RE: Comments on the DEIS for the Horse Heaven Hills Wind Farm Project Draft Environmental Impact Statement

On behalf of TC Cares and Save Our Ridges, and numerous individual reviewers, we are submitting the attached comments on the Horse Heaven Hills Wind Farm Project Draft Environmental Impact Statement.

Figure 2-2: Proposed Disturbance
 Horse Heaven Wind Farm
 Draft Environmental Impact Assessment

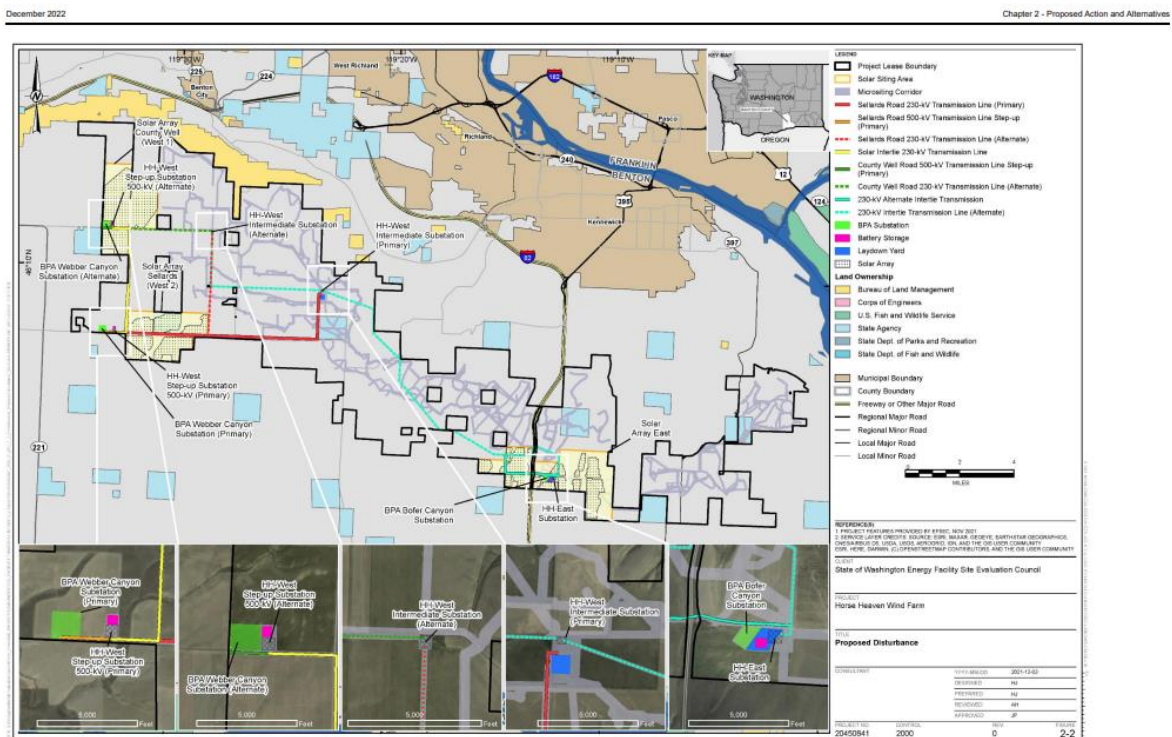
The details on the maps are fuzzy, the colors for the legends are often of such poor contrast it makes it exceedingly difficult to distinguish where specific elements are located and how they relate to project components. While the developer and EFSEC contracts may have used GIS tools to conduct their survey, they did not make use of these technologies in the DEIS effectively.

But neither the DEIS nor the ASC presents maps that identify and number key project location including proposed micro siting corridors, turbines, solar arrays, roads, transmission lines, substations or other infrastructure components. These maps do not offer the detail needed at a scale that allows a reviewer or a government official charged with making decisions the ability to rationally understand and assess the proposed actions and alternatives, and the environmental and social impacts that result the proposed actions and alternatives.

Recommended Actions: *The DEIS needs to use readily available digital interactive GIS tools to make it easier for reviewers and decision-makers to explore and explain the conflicts between the proposed action and alternatives and the required elements of the natural and built environment. Using GIS in the SEPA process and documents can dramatically improve the quality of the communication of key issues related to proposed actions and alternatives and the evaluation of the impacts to the environment and mitigations contemplated.*

The DEIS Section 1.3 Purpose of the Proposed Action states in pertinent part:

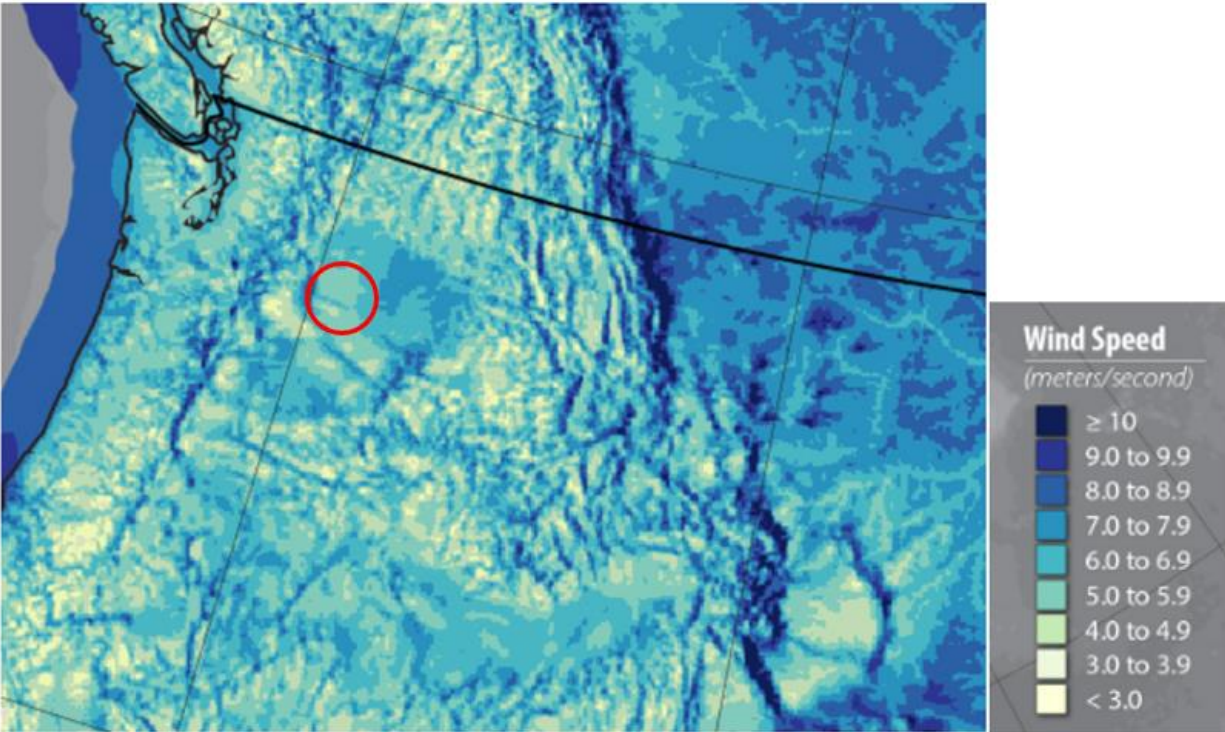
DEIS does not provide any data or information that validates the feasibility or viability of the Project whatsoever. There are no reports, data or other evidence in the record that EFSEC has utilized utility and power experts to guide them in what is needed to meet Washington State's power needs and that the Project is able to meaningfully contribute to them.

The DEIS fails to provide any wind speed information that validates this statement. There is no validation of the 1,150 MW being proposed, no validation of the wind speeds needed to make the project viable, no analysis of the capacity of the existing transmission lines to carry the output of the Project to the grid. There is no challenge to prove that the underlying purpose of the Proposed Action can truly and meaningfully fulfill the goals elucidated by the Legislature in RCW 80.50.010.

Recommended Action: The DEIS must be revised to validate the underlying premise that the Project can meet the legislative goals in RCW 80.50.010. The purpose and Need for the Project must be validated and a real need for the project must be demonstrated with a reasonable degree of certainty.

HANFORD (WA) Wind Rose

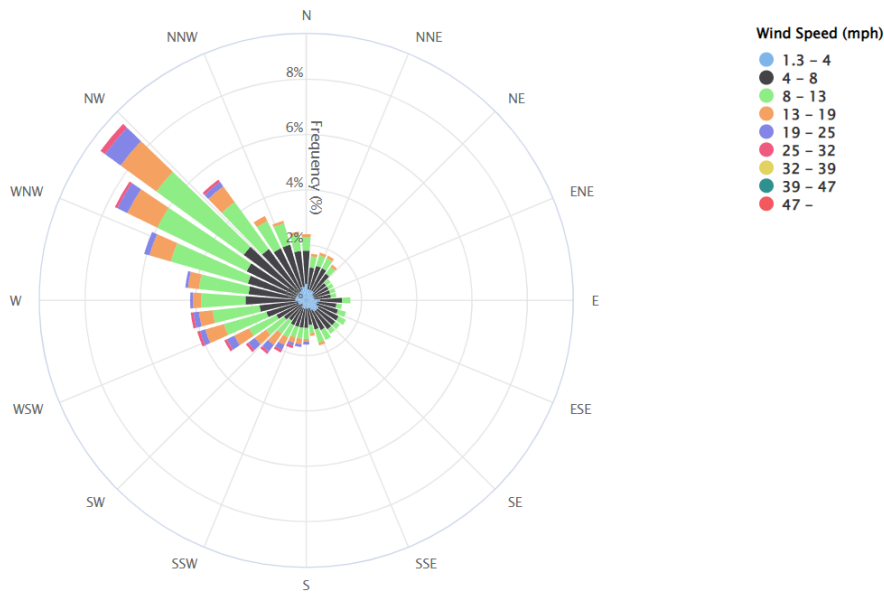
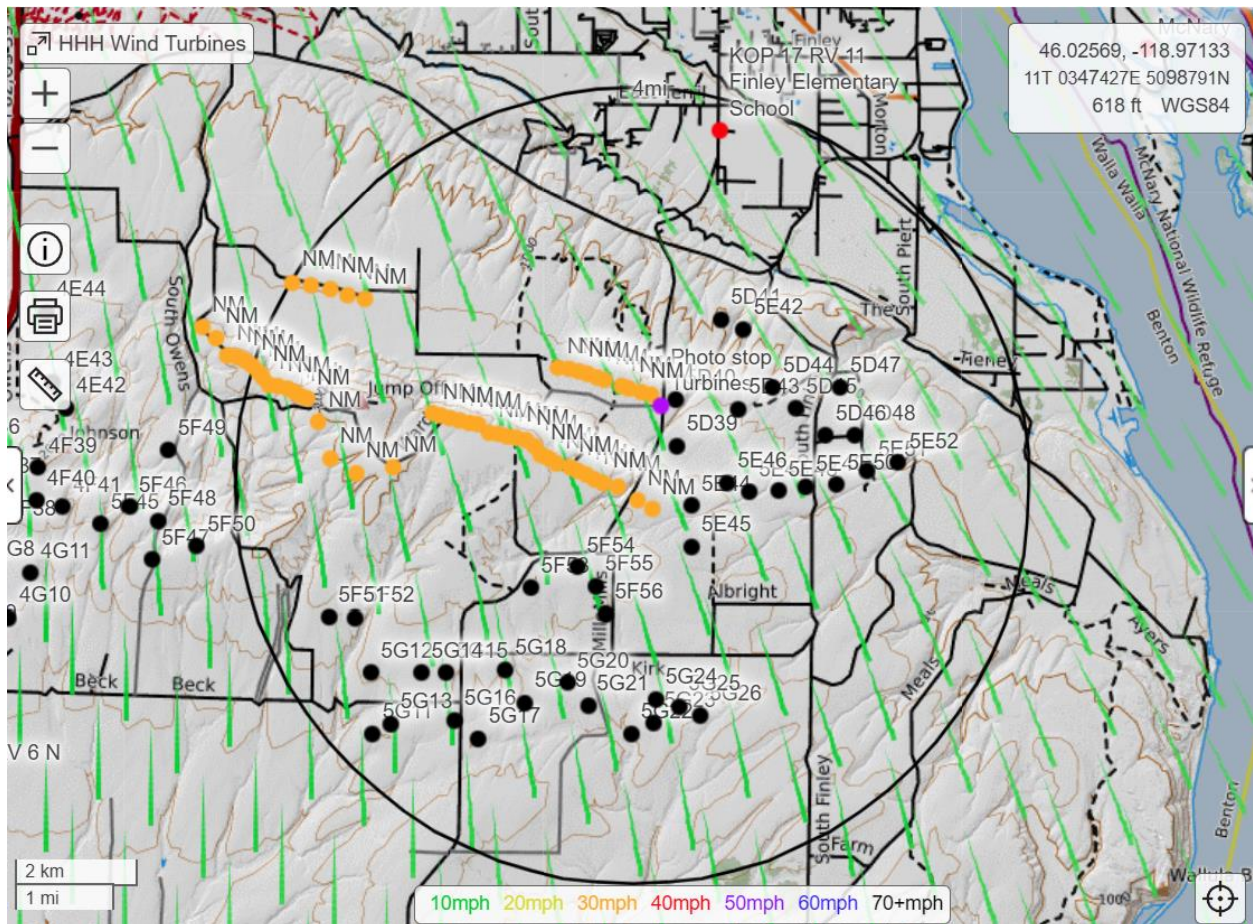
The DEIS needs to include wind rose data using the closest weather stations to the project.

KOP #10 -This KOP was added as a result of SEPA Scoping. The picture location is about 2.5 miles to the Southwest of where was supposed to be taken. As incorrectly taken, the photo is marked high impact and correctly characterize the impact.

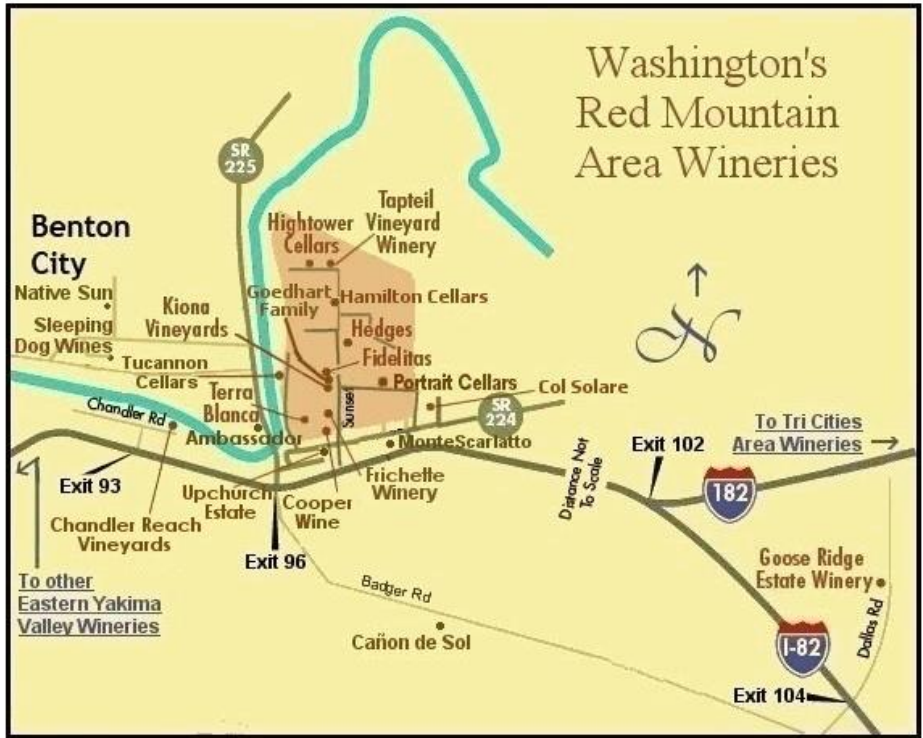
The is where KOP was supposed to be taken. As can be seen, there will be much greater visual Impact.

Recommended Action: The DEIS needs to be revised and reissued with proper coordinates of the KOPs.

Here is the Visual Assessment Map in Attachment A (there are no page numbers) for Viewshed Analysis Results Turbine Layout Option 1.

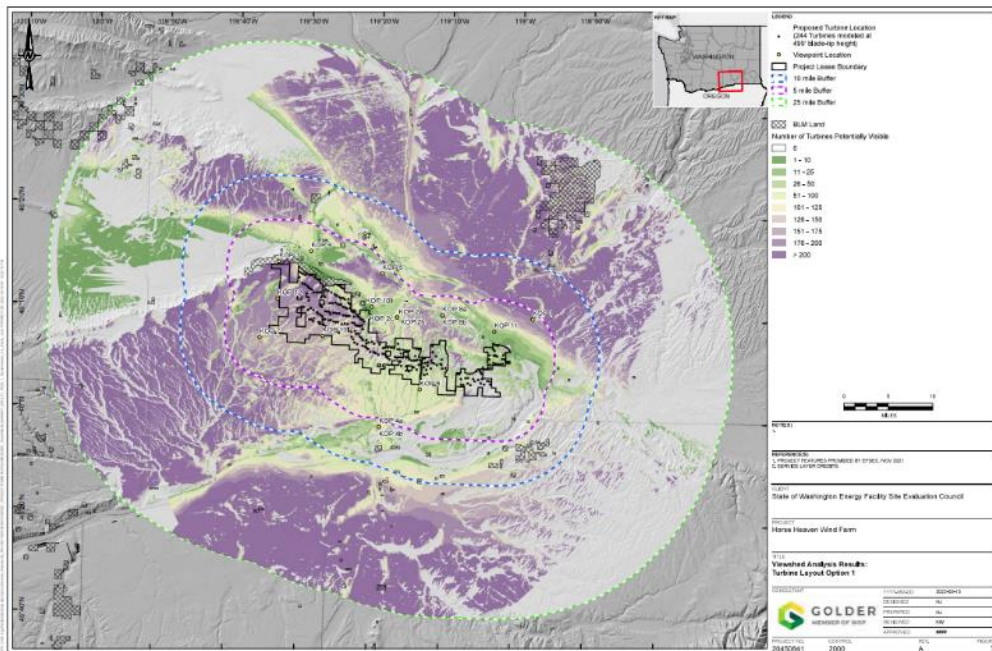
This map is pretty much impossible to use for a reasonable evaluation of the visual impacts by anyone in the affected areas.

Even the color legend makes it difficult to interpret what the colors mean. The gradients for the number of turbines visible go from low to high. The color spectrum starts at white, goes to yellow, then to green, then to yellow again, and then to lavender and purple.

Figure 4.2-5
Locations of Simulation Viewpoints

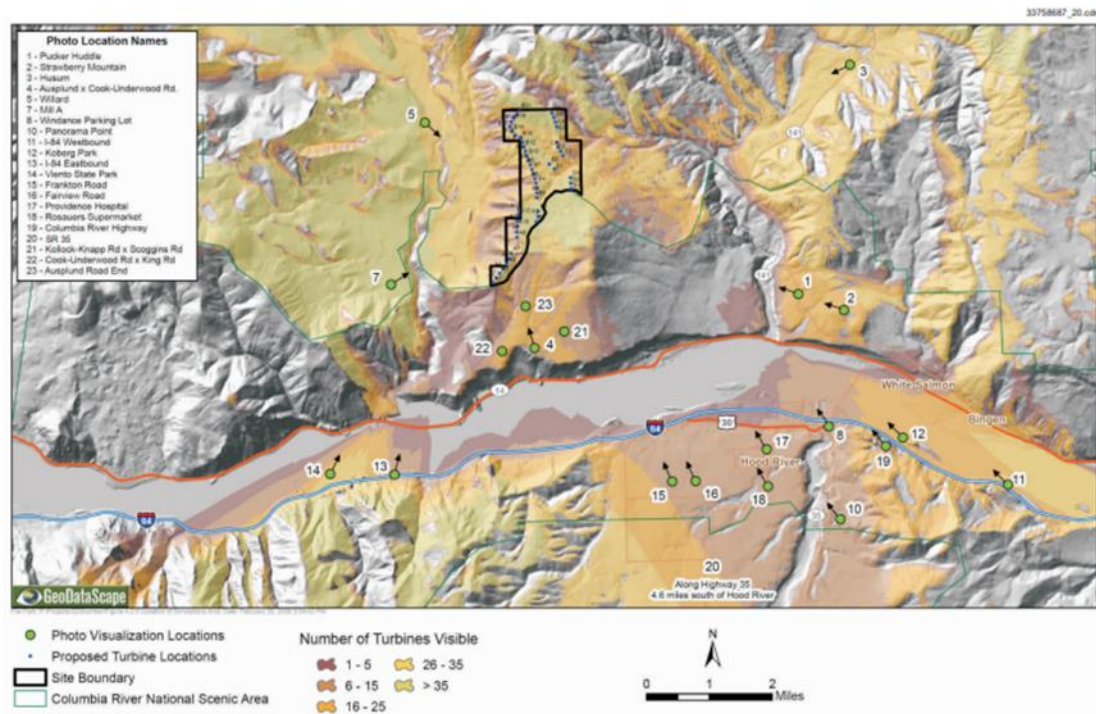
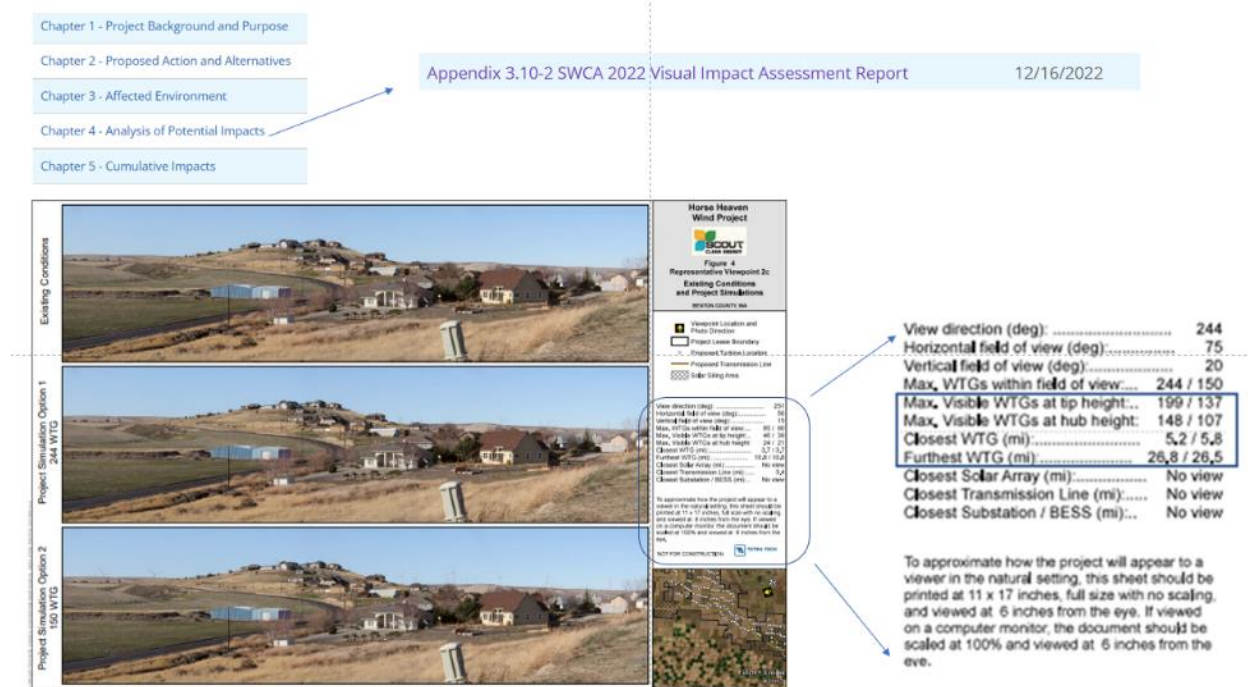
The Horse Heaven Wind Project Visual Assessment includes 11 KOP's. This a very small number of KOPs given the size and geography of the Project. There needs to be more KOPs to properly sample and assess the visual impacts of the Project.

In comparison, the Visual Assessment in the FEIS for the Whistling Ridge Project, with a proposed 50 221 to 262 ft tall wind turbines contains 23 KOP RV locations.

Recommended Action: A project the size of the Horse Heaven Hills Project needs more KOPs to accurately determine and evaluate the visual impacts. More KOPs are needed.

Figure 3.6-2: Wildlife Movement Corridors within the Project Lease Boundary and Project Footprint

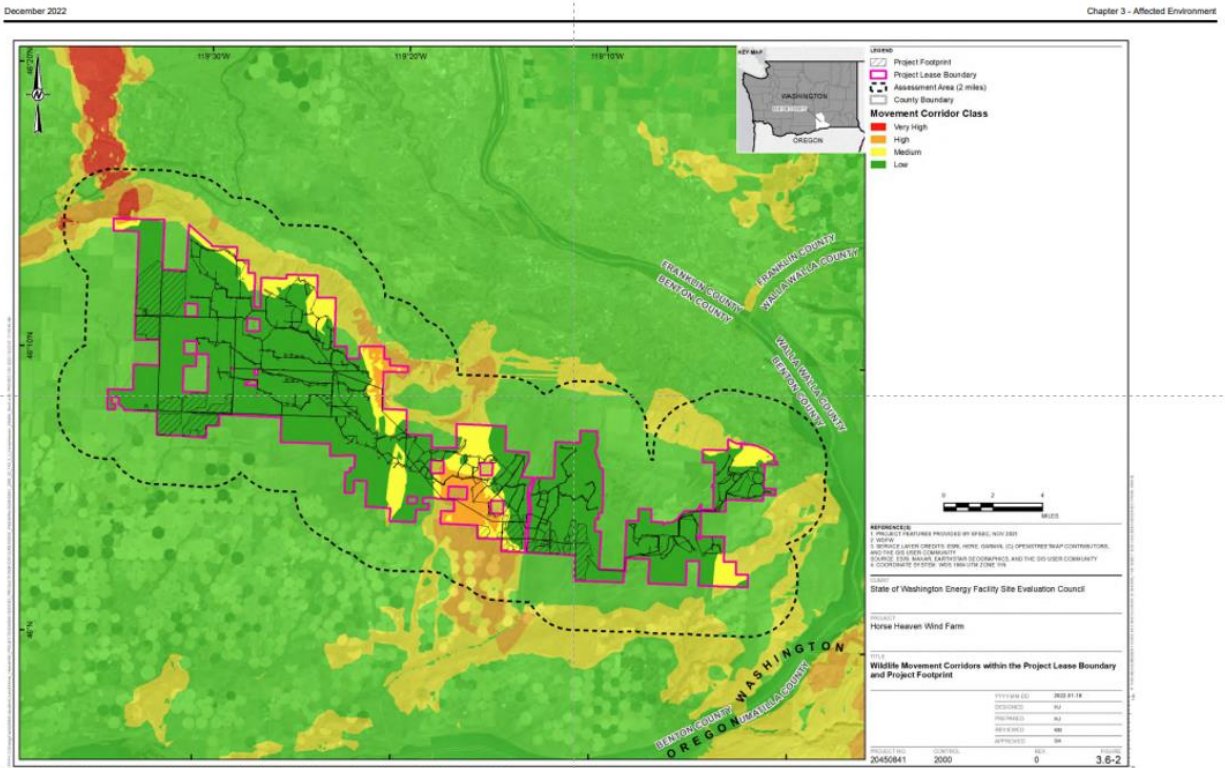
The DEIS and the ASC both contain a map (Figure 3.6-2) identifying wildlife movement corridors within the Project Lease Boundary. This is a poor map, with low detail and resolution and does not readily help achieve the quality of the evaluation required by the WAC to describe the elements of the environment and evaluate the project, alternatives, and mitigation needed to protect the environment.
